Temperature Screening MinMoe Terminal Release Notes (2022-01-26)

Device Model: DS-K1T671TM-3XF DS-K1TA70MI-T DS-K5671-3XF DS-K5604A-3XF	Firmware Version	ARM: ACS_671_3XF_AI3_EN_STD_V3.2.35_build220114 ACS_671_3XF_AI3_EN_NEU_V3.2.35_build220114 MCU: ACS_DS-K1T671_ST1_GML_GM_V1.0.1_build210320 Thermal Module: digicap_thermo-en-gm_V5.5.10_build210406
	SDK	Latest baseline
	iVMS-4200 Version	Latest baseline

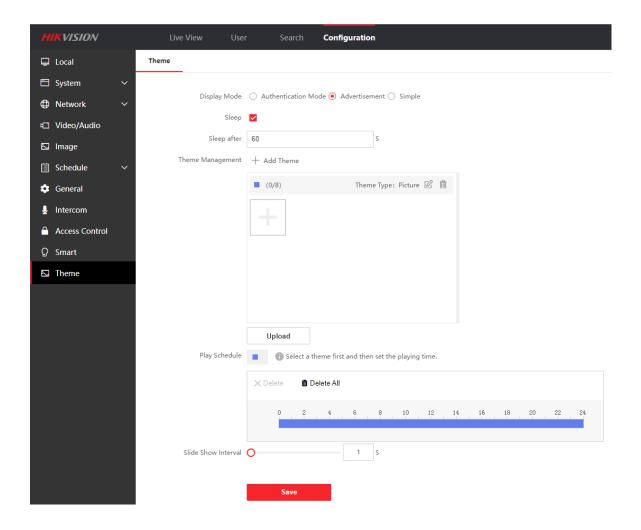
1. Support advertisement mode: upload pictures from web and always display on the screen, recommend using company logo or advertisement picture.

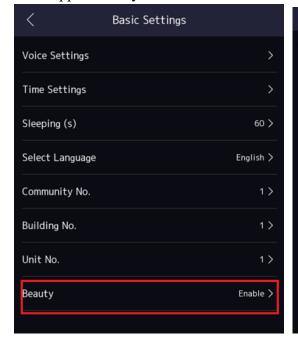
2. Support remote verification function for temperature-only mode

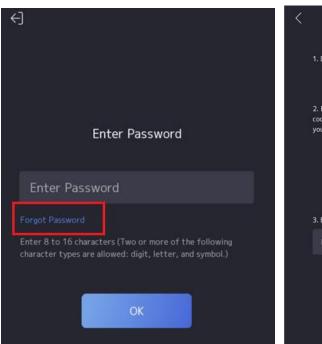
3. Support beauty function

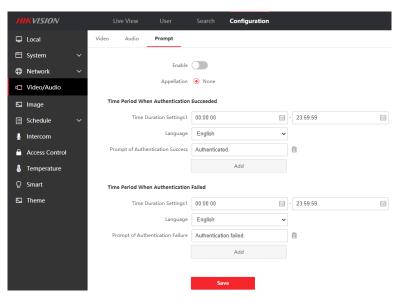
- 1. Support web interface to login and configure device from browser.
- 2. Support TTS (English only) self-defined audio prompt for verification (disabled in default).

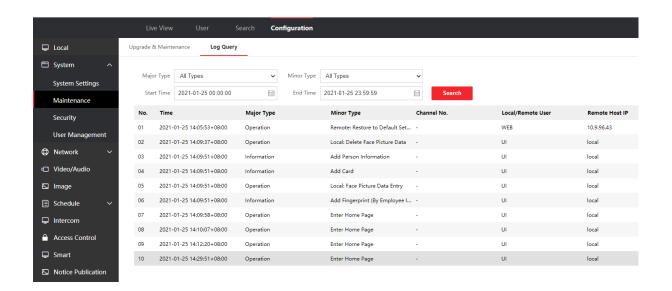
3. Add device operation log query function

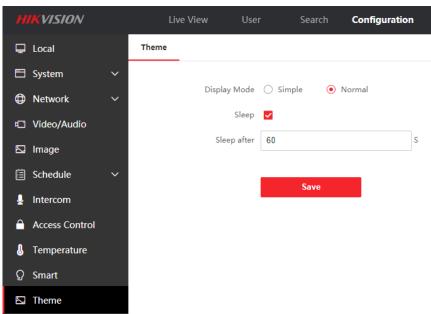
5. Add simple mode (disabled in default), after enable, it will not display live view when verify face

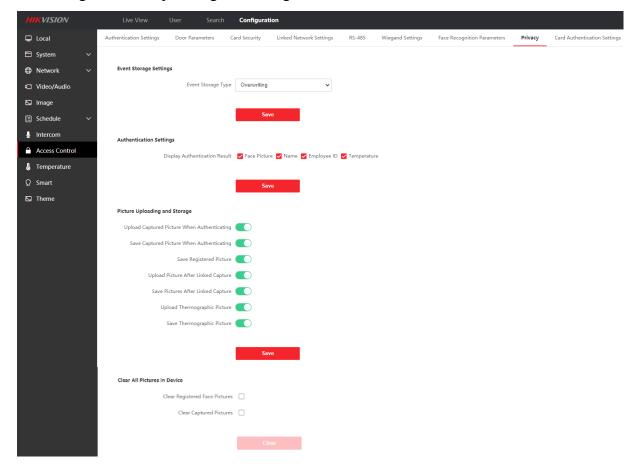
6. Add privacy protection, customer can define the privacy related parameter, such as whether to display photo, name, ID number, temperature after verification, Event Storage Settings, Picture Uploading and Storage, Clear All Pictures in Device

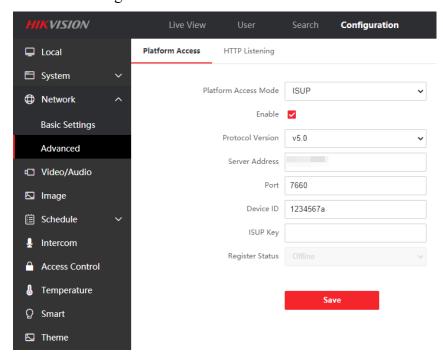
7. Support ISUP 5.0 to manage devices located in different network.

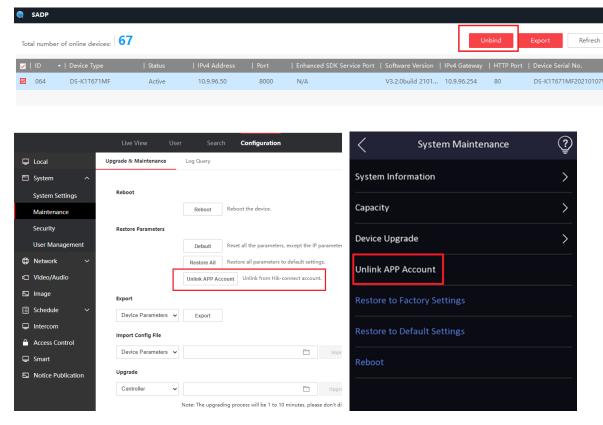
9. Support unbind device with hik-connect account on SADP tool, local UI and web

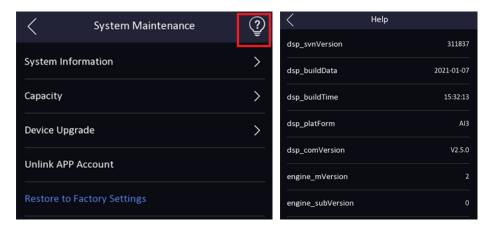
10. Add help interface to check module version for technical support (long press for 3s)

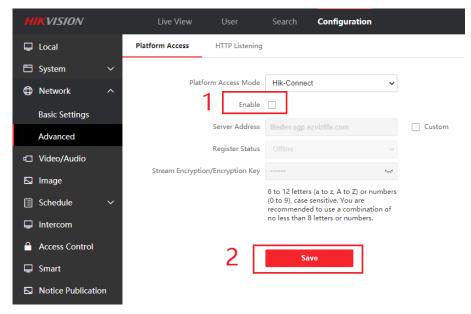
- 6. Upgrade face and mask algorithm. Improve the speed and accuracy of face and dark mask recognition.
- 7. Hik-Connect function is disabled in default for privacy protection, if customer want to manage device from App, please turn on manually in the web.

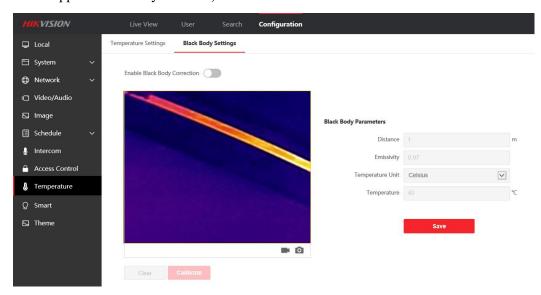
8. Black body parameters are deleted from device UI and move to web interface (DS-K1TA70MI-T doesn't support black body function)

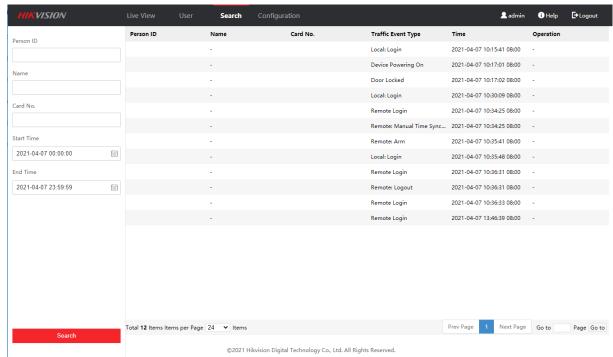
9. Event search function is deleted from device UI and move to web interface.
